City of Alexandria, Virginia

MEMORANDUM

SUBJECT: RECEIPT OF REPORT ON THE WOODROW WILSON BRIDGE PROJECT PLANS FOR JONES POINT PARK AND THE URBAN DECK AND SETTING THE REPORT FOR PUBLIC HEARING ON SATURDAY, NOVEMBER 18 AND COUNCIL CONSIDERATION ON TUESDAY, DECEMBER 12

ISSUE: Receipt of report on the Woodrow Wilson Bridge project plans for Jones Point Park and the Urban Deck

**WASHINGTON STREET
URBAN DECK**

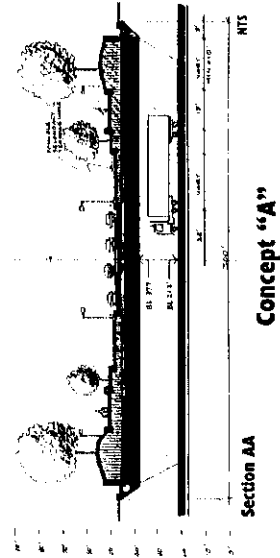
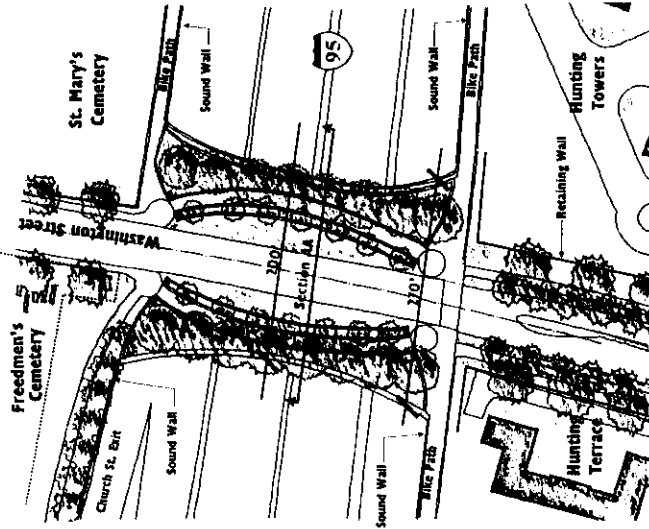
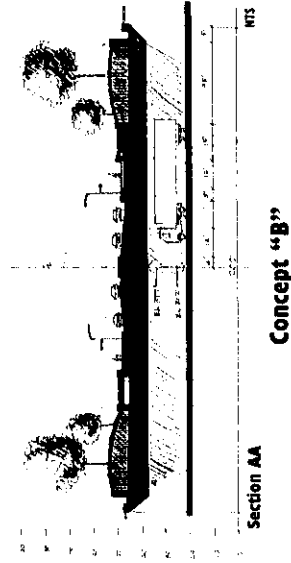
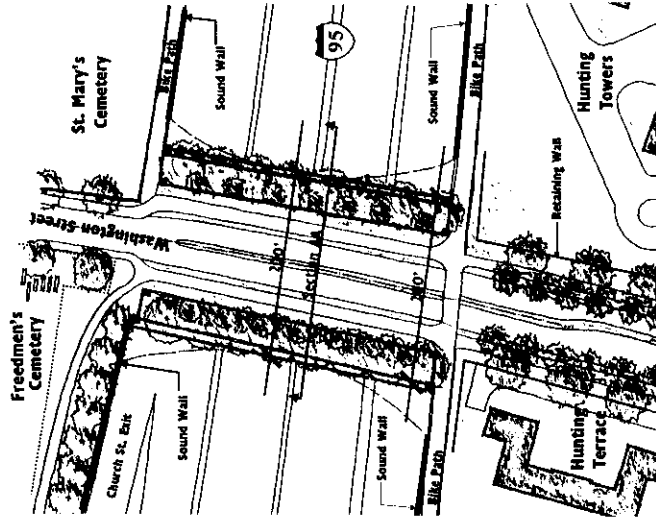
The Park and Recreation Commission and the Waterfront Committee support the smaller deck provided the following issues are addressed: noise and air quality studies show no greater impact on neighbors (noise and air quality are discussed below); recreation fields in the R.O.D. and the settlement agreement are located elsewhere (the City is pursuing this); curvilinear design is favored with a larger deck designed on the east side of Washington Street to provide greater enjoyment by the users of the trail over the bridge; and consideration be given for bas relief sculptures depicting historic events in Alexandria on the sound walls at the southern entrance to the City (staff will discuss with Potomac Crossing Consultants).

Friends of Freedmen’s Cemetery supports a deck which extends to the maximum possible distance to the east and west and the least possible distance to the north and south, while supporting passive recreation and reducing the noise and visual intrusion of the Beltway. The Environmental Policy Commission supports the “Streetscape” concept and suggests the Urban Deck be planted with native trees and other native vegetation to enhance the value of the deck for passive recreation and as a quality wildlife habitat.

6. We are pleased to see the multi-use path from the Rt. 1 interchange connection to the Urban Deck. While we recognize that the Urban Deck drawings are very preliminary, we do want to note that they do not show a multi-use path design that is friendly to through bike or rollerblade traffic. Several comments apply: the turning angles need to be considerably less severe; if the connection to the bridge is going to be through the minimum deck design, consider widening the east side of the deck somewhat to accommodate the multi-use path; if the Mt. Vernon Path could be realigned along the river, the connection from the Rt. 1 path for cyclists may be able to be aligned to coincide with the light at the Hunting Terrace intersection. Pedestrian traffic going into Old Town from the Rt. 1 area should still be routed directly up to the urban deck (to minimize pedestrian travel distances), to cross the urban deck on the west to the light at Church St. If these configurations are not possible, a pedestrian/bicycle activated light would be an absolute necessity to cross Washington St. just south of the Urban Deck.

The AAC supports the smaller urban deck for **Washington Street**. This will help to protect the cultural resources in Freedmen's Cemetery and provide a fitting gateway to the historic City of Alexandria. The AAC supports multiple features, including cultural resources, at the **Jones Points Park**. We conclude that further, more careful investigation of cultural resources is needed in order to provide an adequate basis for interpretation and protection. Finally, the AAC believes maintenance plans are needed for both Washington Street and Jones Point Park. Our letter provides details on these recommendations.
